ADDENDUM NO. 1  
To the Plans and Specifications for:

**IMPLEMENTATION OF BMPs WITHIN THE SUNSET BEACH  
WATERSHED (PHASE VI) (674) (SCHEDULES A-G)**

City of Treasure Island

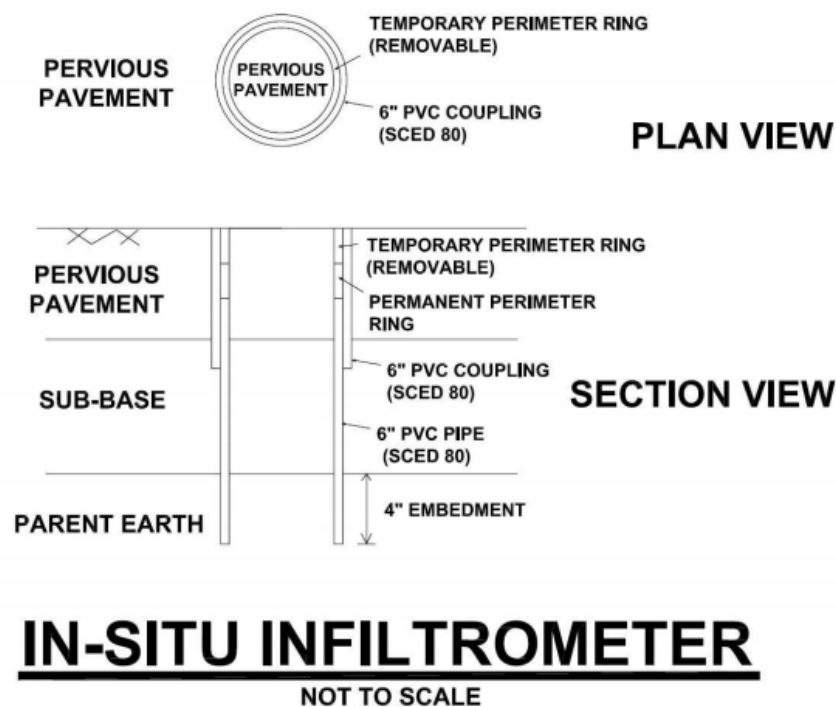
GC.18 The insitu infiltrometer shall be constructed per the below detail:

TYPICAL SECTION VIEW

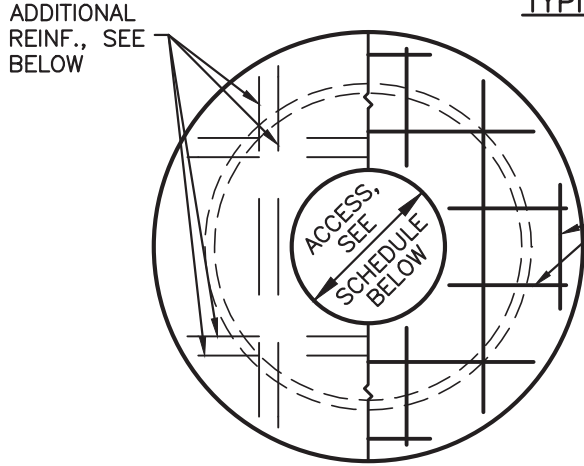
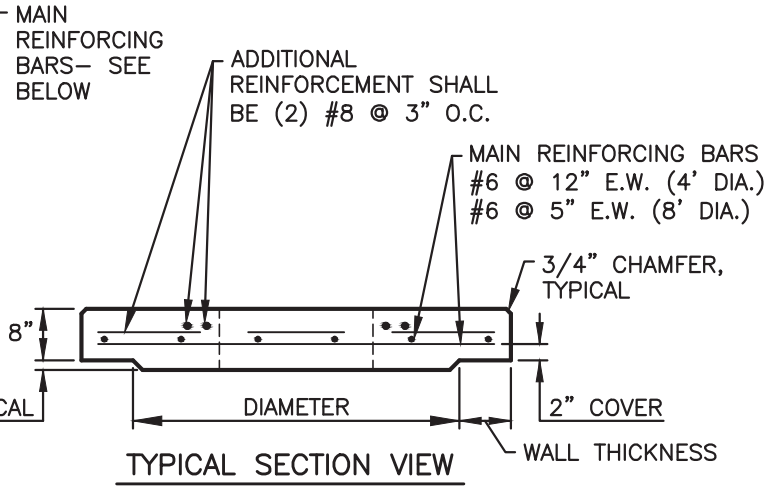
- GC.14 A detail for sanitary lateral conflict structures has been attached to this addendum.

- PROVIDE MINIMUM 8" SOLID WALL BETWEEN ALL OPENINGS FOR PIPES. SEAL BETWEEN PIPE AND STRUCTURE WITH NON SHRINK GROUT.
- ALL BRICK SHALL BE CONCRETE OR CLAY BRICK AND SHALL HAVE A MINIMUM 3/4" CEMENT PLASTER COATING ON ALL SURFACES.

- BENCH SHALL SLOPE @ 1:12 MINIMUM.
- ALL EXPOSED EDGES TO HAVE 3/4" CHAMFER.
- ALL REINFORCING STEEL SHALL HAVE A MINIMUM 2" CONCRETE COVER.
- A PROTECTIVE COATING SHALL BE APPLIED TO THE INSIDE AND OUTSIDE SURFACES DRAINAGE STRUCTURES. THE PROTECTIVE COATING SHALL COVER THE COMPLETE EXTERIOR AND INTERIOR SURFACE OF THE STRUCTURE (INCLUDING CONE SECTIONS, RISERS, AND INVERT) FROM THE BOTTOM SLAB TO THE GROUND SURFACE EXCLUDING THE COVER CASTING, LID, AND THE HORIZONTAL PLANE OF THE PIPE PENETRATIONS OR CUT OPENINGS. THE UNDERSIDE OF THE BOTTOM SLAB MAY ALSO BE EXCLUDED AT THE CONTRACTOR'S OPTION. THE PROTECTIVE COATING SHALL BE ONE COAT OF COAL TAR EPOXY, KOP-COAT BITUMASTIC 300-M OR APPROVED EQUAL. THE DRY 9 MILS IN THICKNESS.
